KWM-380 TRANSCEIVER (622-5093-101)  
HF-380 TRANSCEIVER (622-3580-101)  
RECEIVER-EXCITER CIRCUIT CARD A3 (638-6908-001)

SERVICE BULLETIN NO 1

PRODUCT IMPROVEMENT

P/O Receiver/Exciter A3, Component Installation Diagram  
Figure 1 (Sheet 2)

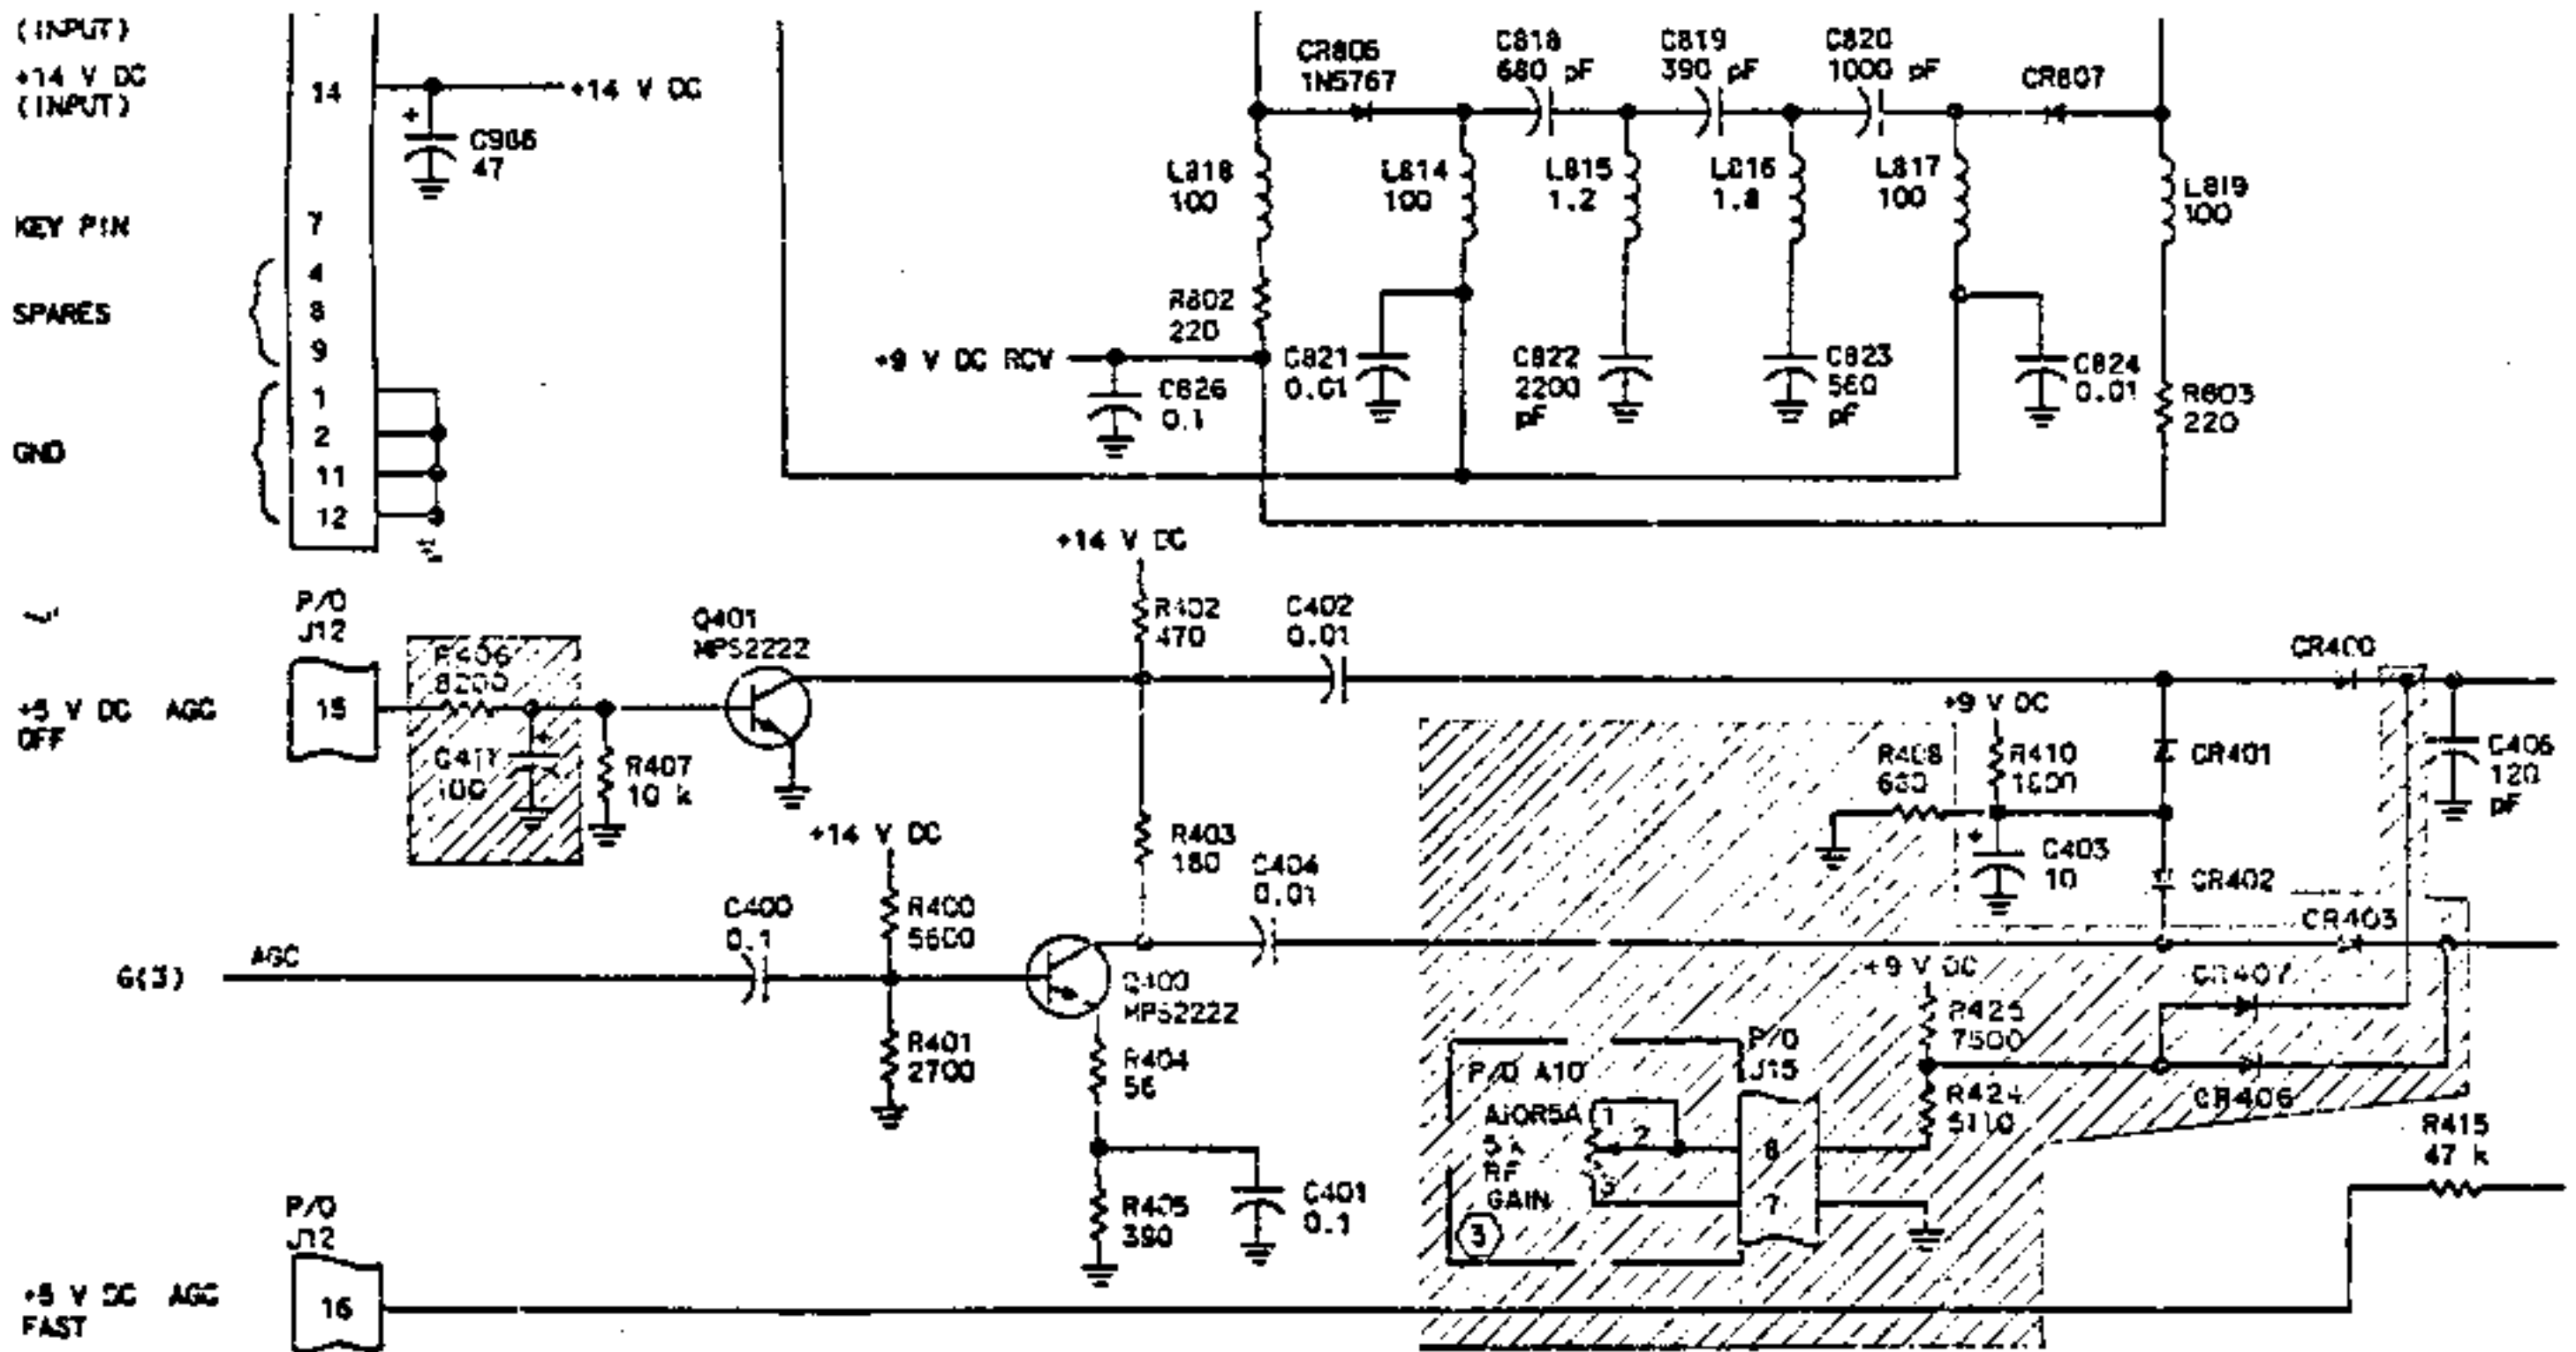
- K. Position 1N4454 diode CR406 (353-3644-010) as shown in figure 1, detail B, section BB. Connect the cathode end to the contact installed in step I.

- L. Position 1N4454 diode CR407 (353-3644-010) as shown in figure 1, detail B, section BB. Connect the cathode end to the contact installed in step J.

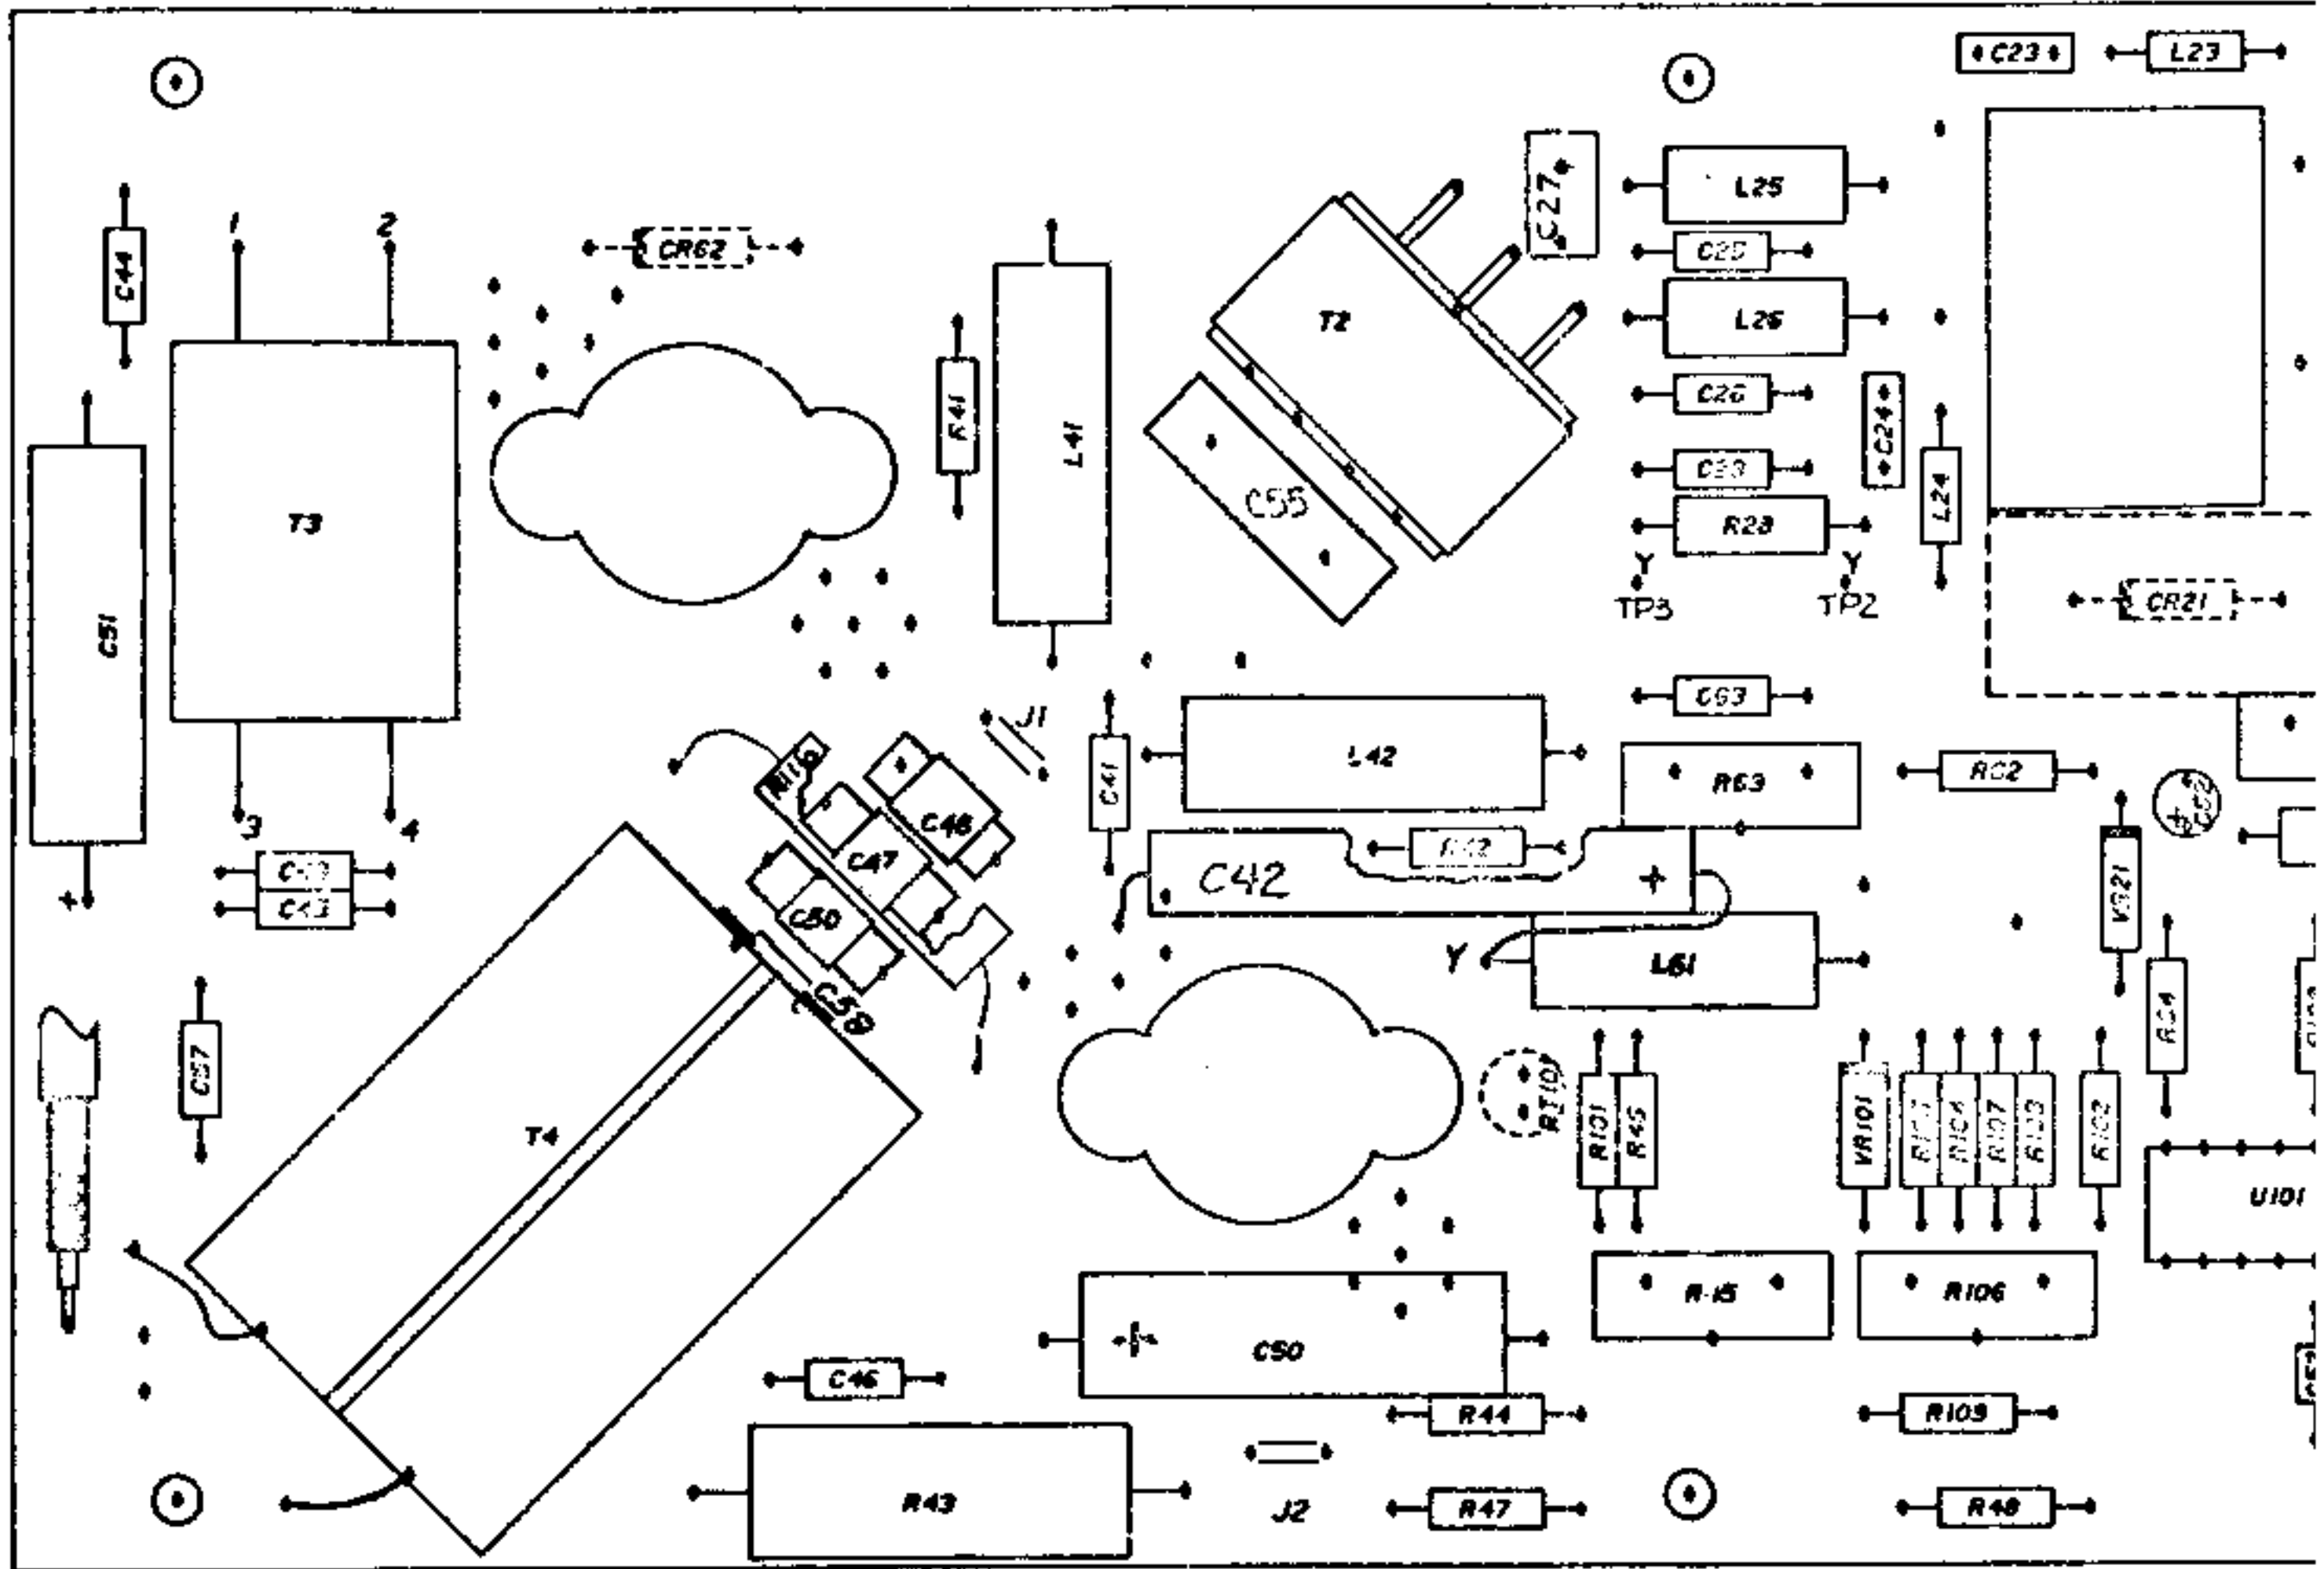
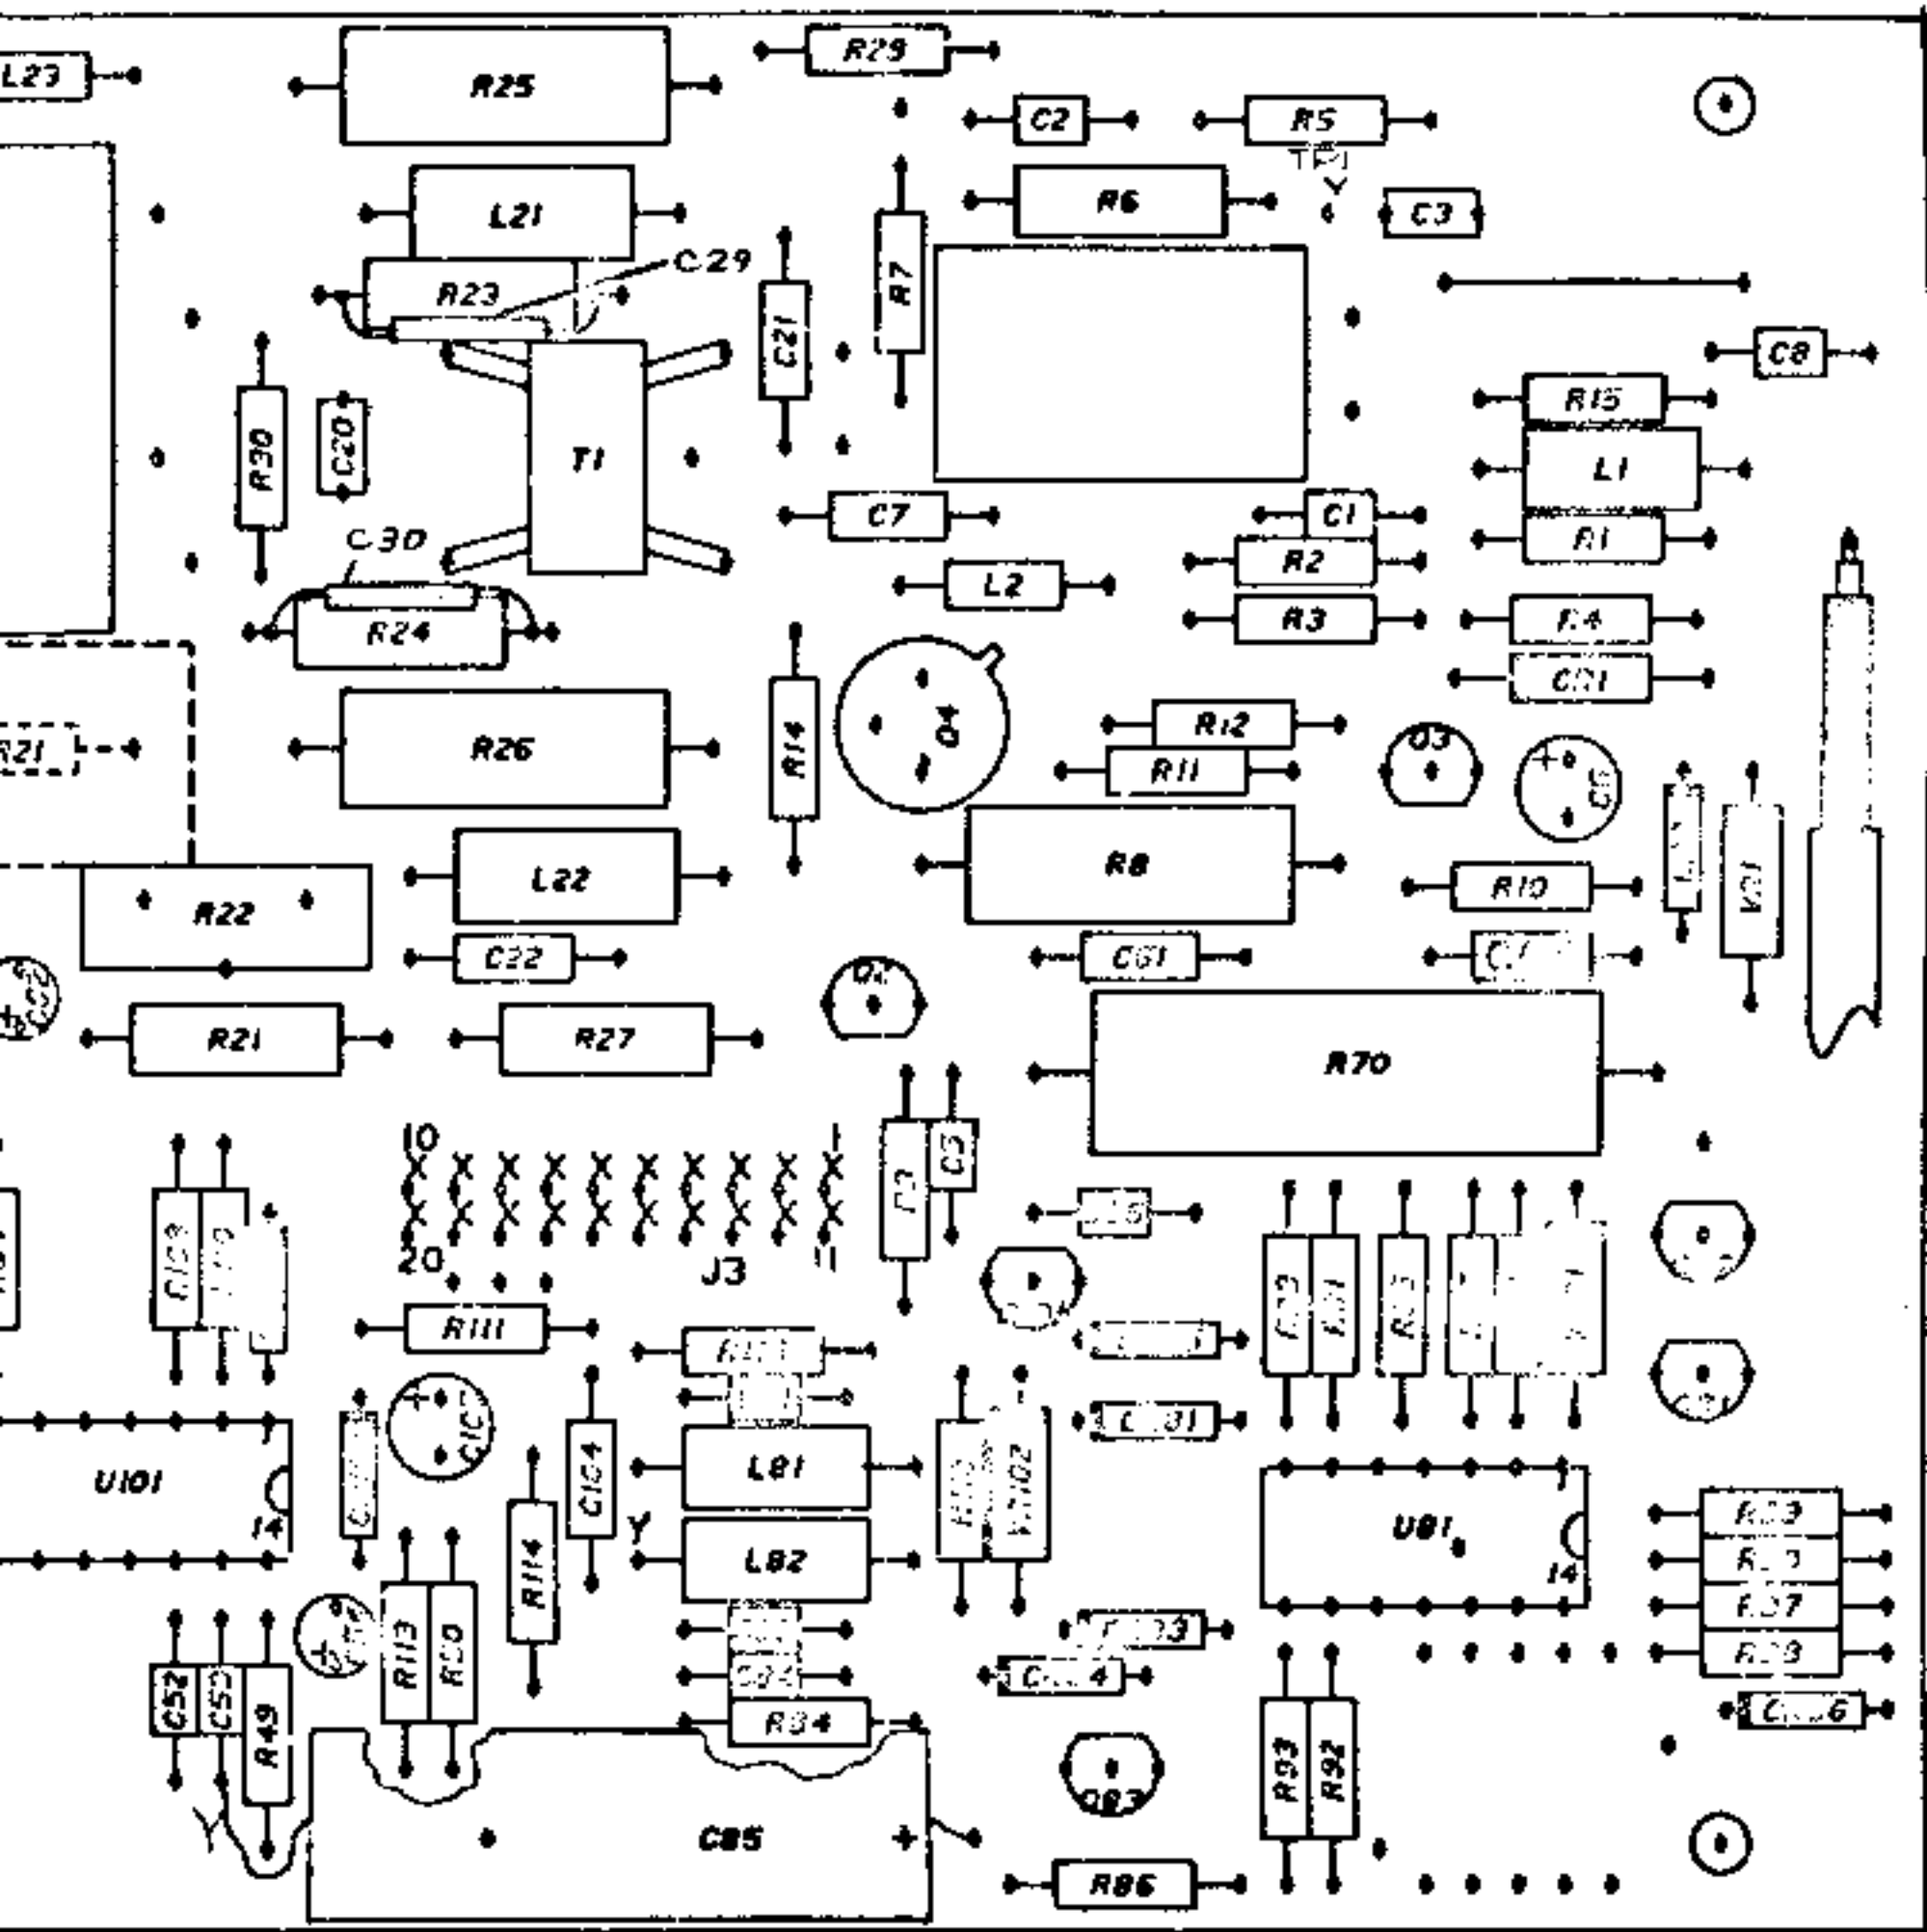
NOTE: Do not remove circuit card A1A1 from power amplifier/heat sink assembly A1. Refer to figure 1 while performing steps E through T. Refer to figure 2 for a schematic diagram of the latest configuration.

- E. Remove 1500-pF capacitor C55 by cutting the leads close to the body of the component. Leave the capacitor leads soldered into the circuit card.
- F. Install a 1000-pF capacitor (912-3315-000), connecting the leads to the leads of the capacitor removed in step E.
- G. Install a 2.7- $\mu$ H coil L44 (240-2715-180) as shown in figure 1, detail A.
- H. Remove 0.27- $\mu$ H inductors L23 and L24 by cutting the leads close to the component body. Leave the inductor leads soldered into the circuit card.
- I. Install two 3.3- $\mu$ H inductors (240-2029-000), connecting the leads to the leads of the inductors removed in step H.
- J. Install 100- $\Omega$  resistor R123 (745-1310-000) in parallel with L23. Wrap the resistor leads around the coil leads and solder.

- Q. Remove and discard 68- $\Omega$  resistor R116.
  - R. Install electronic components assembly A1A2 (647-2781-001) onto the circuit card as shown in figure 1 using the existing hardware.

- S. Wind two turns of brown wire (422-0795-000) in transformer T3 as shown in figure 1, detail B. Connect to A1A2 assembly as shown in figure 1, detail D. If the transformer core has potting in the holes, carefully clear a way for the brown wire, using a stiff wire such as a straightened paper clip.

- T. Wind two turns of red wire (442-0796-000) in transformer T2 as shown in figure 1, detail D. If necessary, clear the core of potting as in step S.

- NOTE: The added wires in steps S and T must be oriented as shown in figure 1, details B and C, to prevent oscillation.
- U. Reassemble the transceiver in the reverse order of disassembly.

NOTE: LEADS FROM T2 AND T3 MUST BE CAREFULLY POSITIONED AS SHOWN TO PREVENT DESTRUCTIVE OSCILLATION.
